Update for Ardersier and Petty Community Council – January 2021

Picket Fence Thickener

Inlet Works

Drawing 2: Elevation of proposed Inlet Works, with part of handrail and equipment above 9.7 metres AOD highlighted in red.

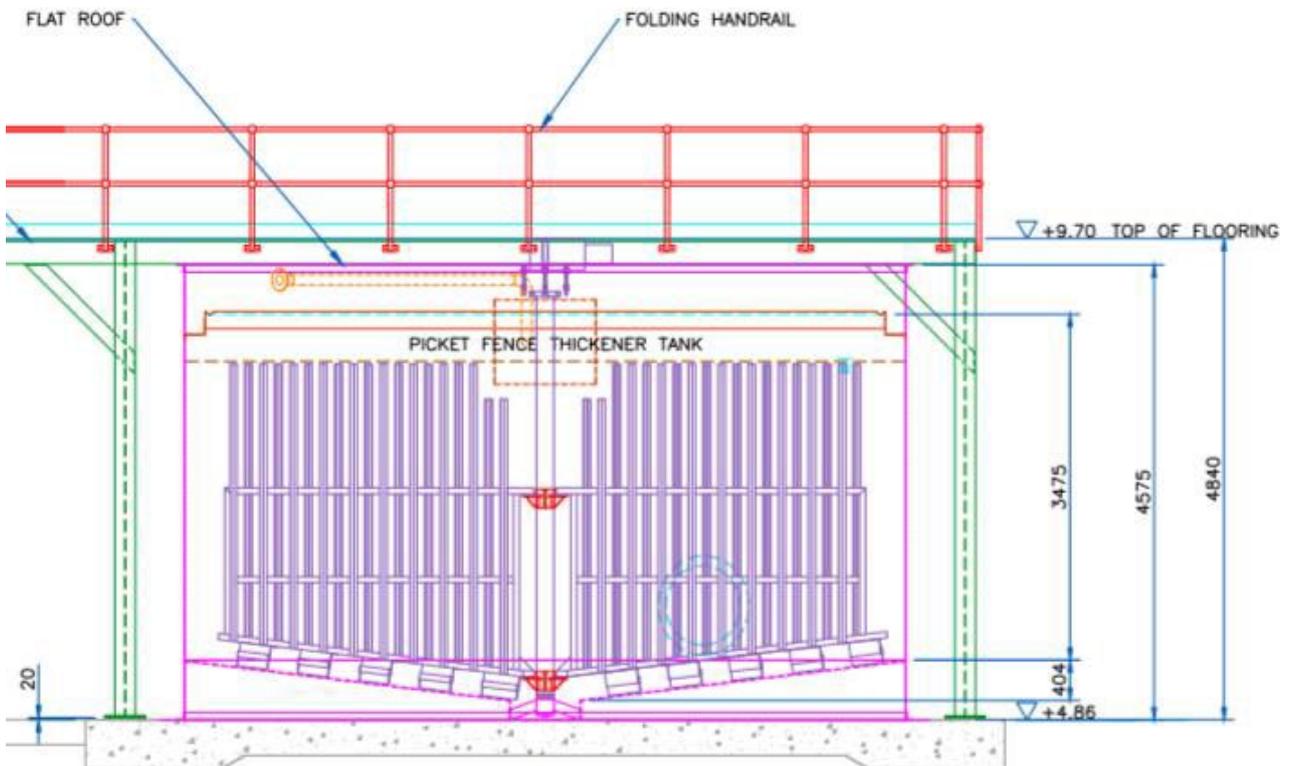
- Some parts of the inlet works are higher than we originally anticipated. This includes the top parts of some of the screens which 'sieve' the sewage, but stick up above the main structure, and part of the handrailing which keeps our operatives safe when they are maintaining the plant.

- We have looked at how we could lower the inlet works. This would involve creating a large excavation over 2m deep and installing a sheet pile wall along one side of it. We would then lower the roadways, install new drainage and lay a new concrete slab for the inlet works to rest on. Existing pipework, electrical ducting and lighting would have to be reinstalled.

- Lowering the inlet works means that gravity can no longer be used to allow the sewage to flow around the treatment process and a new pumping station would have to be installed. This involves sinking a shaft into the ground to create a well, and then installing large submersible pumps into the shaft with associated power supply and electrical controls. Whilst this is possible, it introduces a costly additional item to our process which will require maintenance for the life of the plant and will pump constantly with a carbon impact and potentially additional noise.

- Given the significant financial and carbon cost of lowering the inlet works, as well as the operational risk created, we feel that the right thing for us to do is to provide the further information and visualisations that have been requested by the Planning Committee and seek consent for the increase in height of the tallest parts of this structure; as well as for the electricity substation which is much lower.

- We will explore whether the visual impact of this can be reduced via the painting of the higher parts of the structure and provide visualisations.

Drawing 1: Provisional cross-section of revised Picket Fence Thickener (includes internal arrangement within the tank which will not be visible). The handrail is shown upright, but would be folded down when not in use. A final drawing will be provided to the CLG and via the planning process.

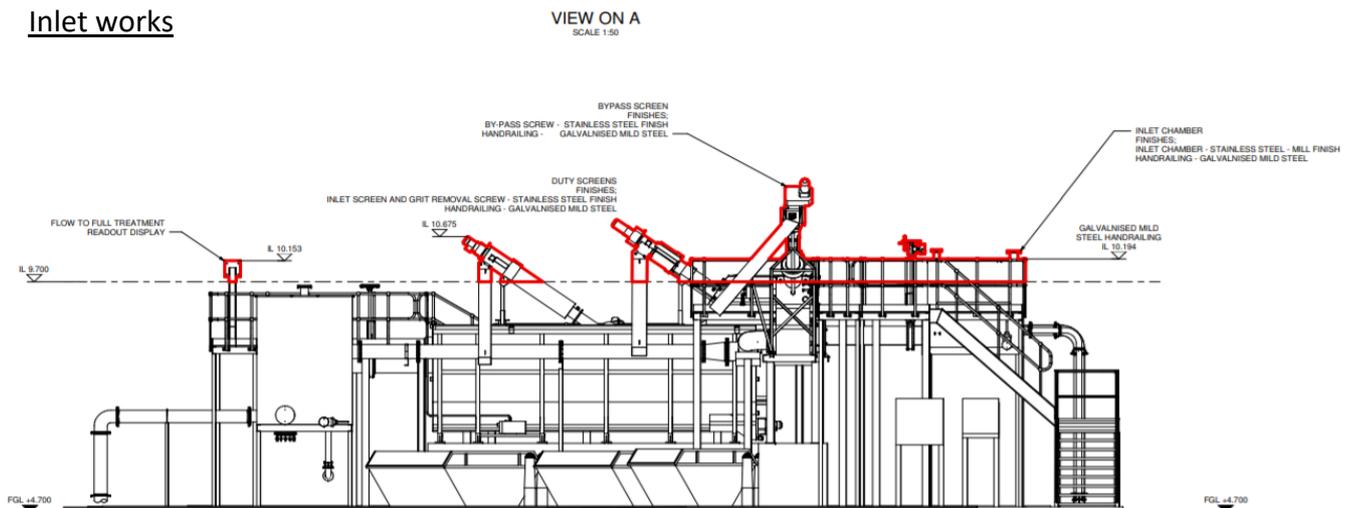
- The Picket Fence Thickener tank is part of the sludge treatment process.
- Further work with the suppliers of the Picket Fence Thickener tank has identified an option to lower this structure so that the height of the permanent parts of the structure would be 9.7 metres AOD (5 metres above ground level), which was the height indicated in the 2016 revision to our original planning consent.

- We would still require an access gantry, but the fixed base of this would be included in the 9.7m height and we are developing a system for the handrails to be collapsible. The handrails would then only need to be in place for infrequent operational access and would be folded down afterwards.

- While we are responsible for the situation that has arisen, we cannot compromise on the safety of our team so we are in the process of confirming that we can put a system of work in place to allow this arrangement to be managed safely. We will also paint the gantry and handrails to match the colour of the tank itself.
